VILLAGE OF TWIN LAKES

MEMORANDUM

SUBJECT: Design Review for the proposed addition to Randall Consolidated School

Review and consider for approval the application for Design Review from Groth Design Group (Applicant) and Randall Consolidated School Joint #1 (Owner) for a Site Plan and Signage on tax parcel # 85-4-119-162-0902.

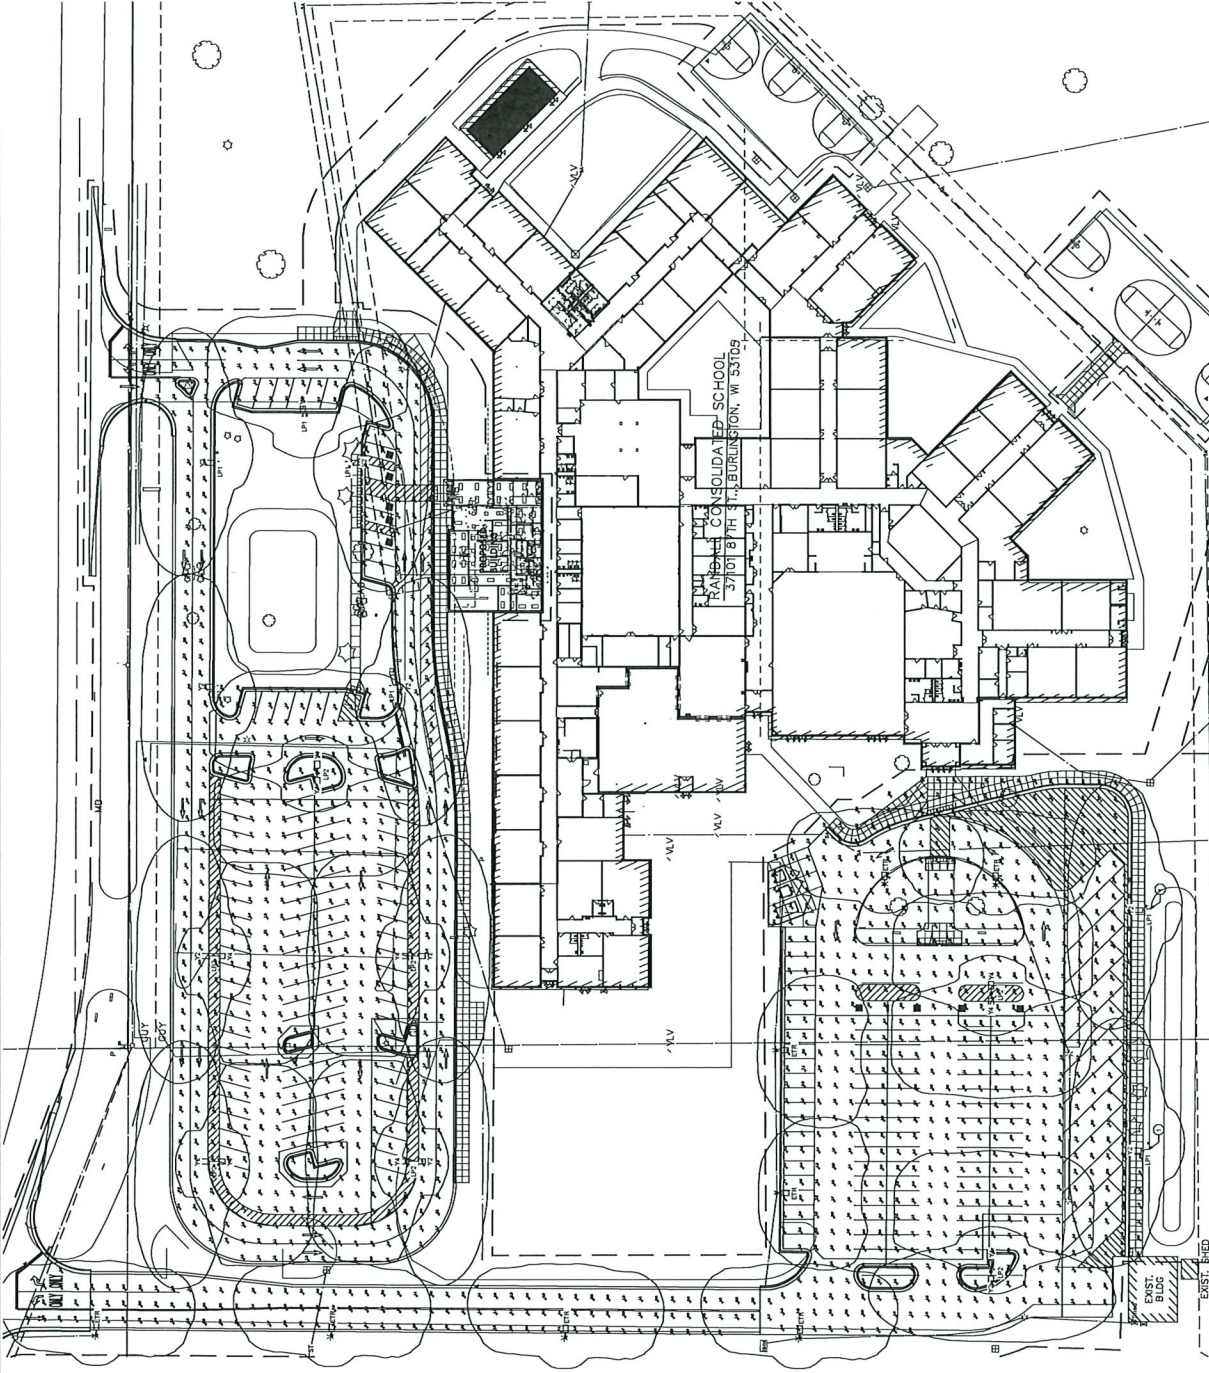
- Type – Conforms
 - Display Surface Size – Conforms
- Parking and Loading Area Standards – A reconfiguration of the existing parking is proposed, converting all parking spaces to angled parking and orienting parking aisles east to west, and replacing the bus parking with standard vehicle parking. An additional 8 parking spaces are proposed, 5 of which are ADA spaces with loading areas shared between every 2 spaces in front of the new building addition. The existing angled parking on the easternmost driveway is being removed and replaced with 6 standard parking spaces. The overall change in the number of parking spaces has not been indicated. The south parking lot has a new garbage screening area proposed and a new row of bus parking stalls proposed along the southern edge. New landscaping islands are proposed throughout the new parking lots. The existing driveway in the middle of the three existing driveways is proposed to be removed.

- Parking setbacks – Conforms
- Lighting – Conforms
- Garbage and Refuse – The proposed new refuse area appears to include screening. The storage and screening of refuse must be described in the plans. All sites shall be planned to provide screening and storage of garbage and refuse acceptable to the Plan Commission.

- Access – The proposed design eliminates the center access drive to the parking lot and widens the easternmost driveway access to accommodate three driving/turning lanes. Changes to access and streets are subject to Engineering Review.

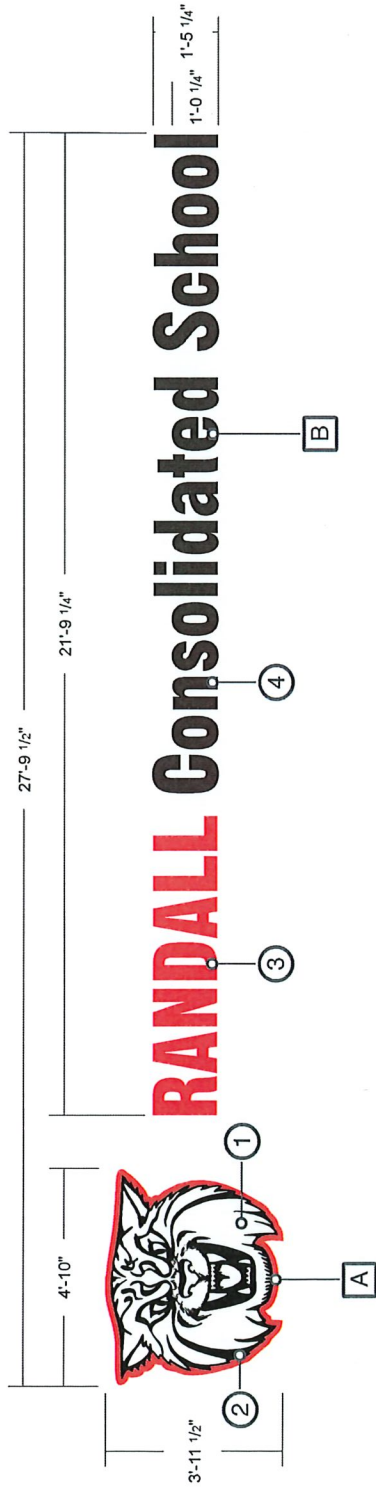
- Building
 - Using the appearance of the façade shown in the “Building Sign Concept” submittal, the proposed building is faced with masonry and glazing. According to the Design Review Requirements (17.42.040) “The front façade and street side (sic) façade shall be faced with concrete, brick masonry, stone, metals or other materials architecturally integrated in the building design. Unfaced concrete block, structural concrete, prefabricated metal siding and the like are not permitted on façade areas.”
- Landscaping
 - Additional landscape islands are proposed in the parking lot areas.

- Signs
 - Proposed Building Sign:
 - Orientation – Conforms
 - Height – Conforms
 - Size – Conforms (25-300SF permitted; ~100 SF proposed)
 - Setback – Conforms

EAST + WEST ELEVATIONS
1/2" = 1'-0"

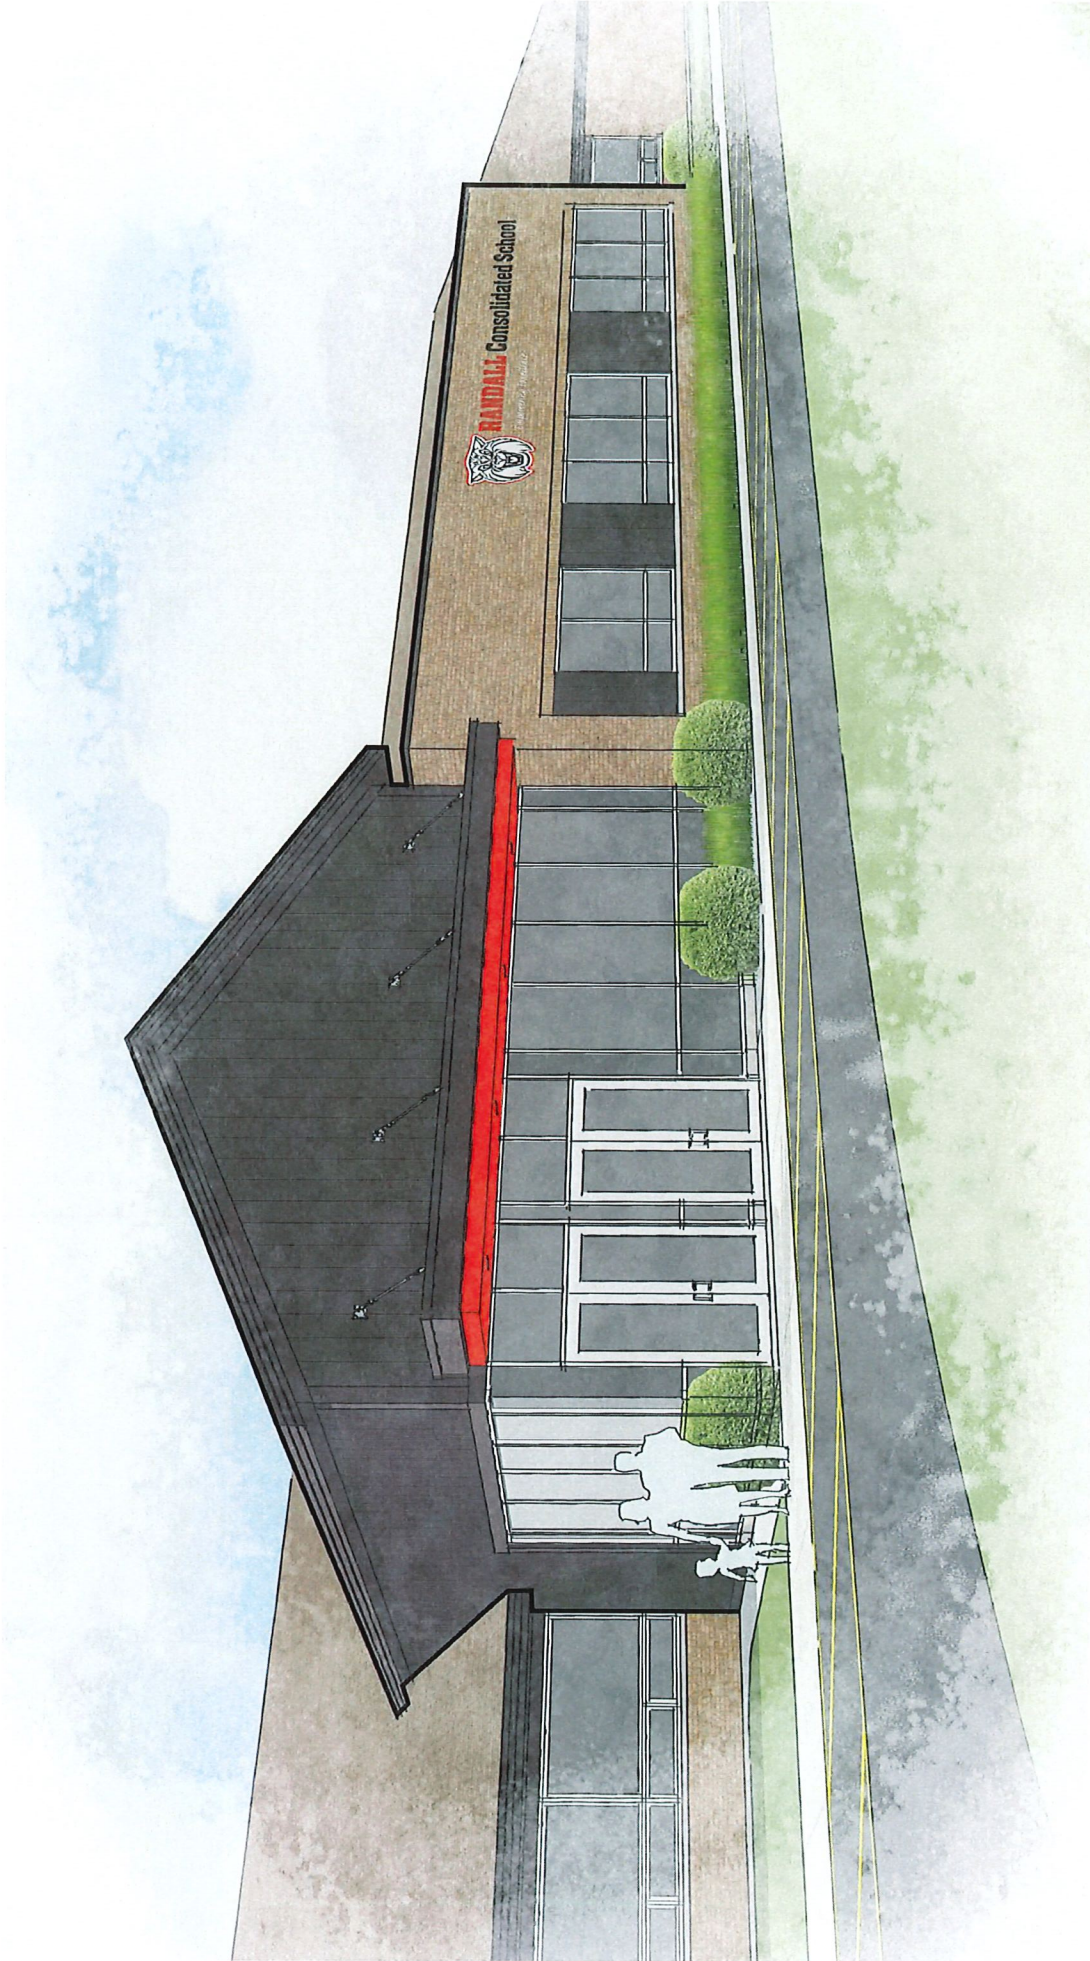
- Type – Conforms
 - Proposed Monument Sign:
 - Orientation – Conforms
 - Height – Conforms
 - Size – Conforms (25-300SF permitted; ~64 SF proposed)
 - Setback – Conforms
